**ON-SITE SEWAGE DISPOSAL SYSTEM
HOWARD COUNTY HEALTH DEPARTMENT
BUREAU OF ENVIRONMENTAL HEALTH**

Hatfields Equipment IS PERMITTED TO INSTALL ALTER
ADDRESS: P.O Box 519 Ann Jctn MD 20701 PHONE NUMBER: 410-984-0047
SUBDIVISION: Riverwood LOT NUMBER: 48
ADDRESS: 11045 Hunters View Road PROPERTY OWNER: Winchester Homes Inc.
SEPTIC TANK CAPACITY (GALLONS): 2000 OUTLET BAFFLE FILTER REQUIRED
PUMP CHAMBER CAPACITY (GALLONS): 1000 COMPARTMENTED TANK REQUIRED
NUMBER OF BEDROOMS: 4 APPLICATION RATE: 1.2
SQUARE FOOTAGE OF HOUSE: >3500
LINEAR FEET OF TRENCH REQUIRED: 165

RIVERWOOD PHASE 2
PLAT No. 19722
LOT No. 48
 11045 HUNTERS VIEW ROAD
 3rd ELECTION DISTRICT
 HOWARD COUNTY, MARYLAND
 SCALE: 1" = 50' DATE: 12-16-10

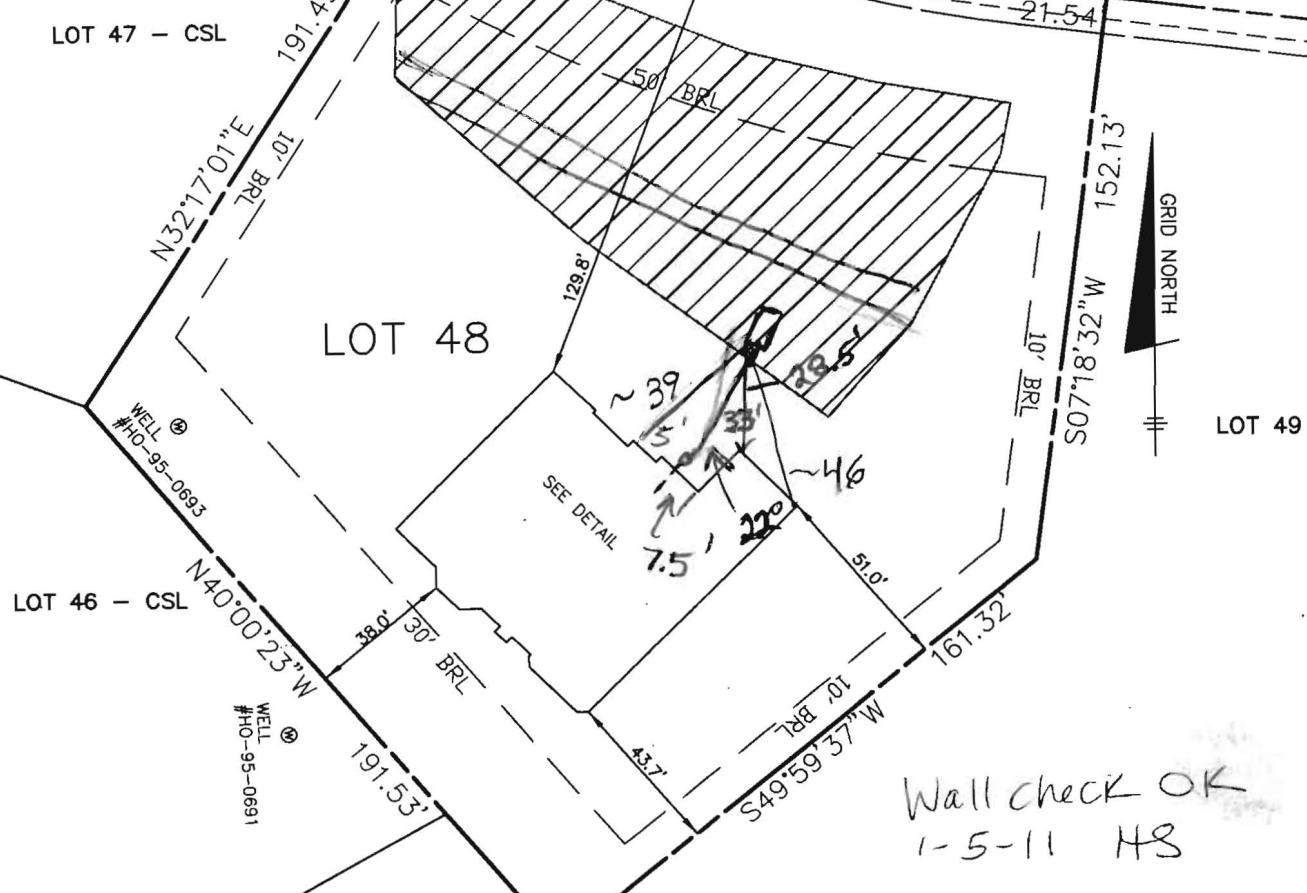
2/10/2011 Able to get to highest part of easement by gravity. However this will sacrifice part of septic easement. Cannot do trench layout. Frozen fell on upper part of easement. Will do trench layout when backhoe is available. BB

2/14/2011 Trench layout done. Tank set and house connection made. BB 2/15/2011 System finished. O.K. to backfill. Installer didn't connect to trenches with a tee as I suggested. BB
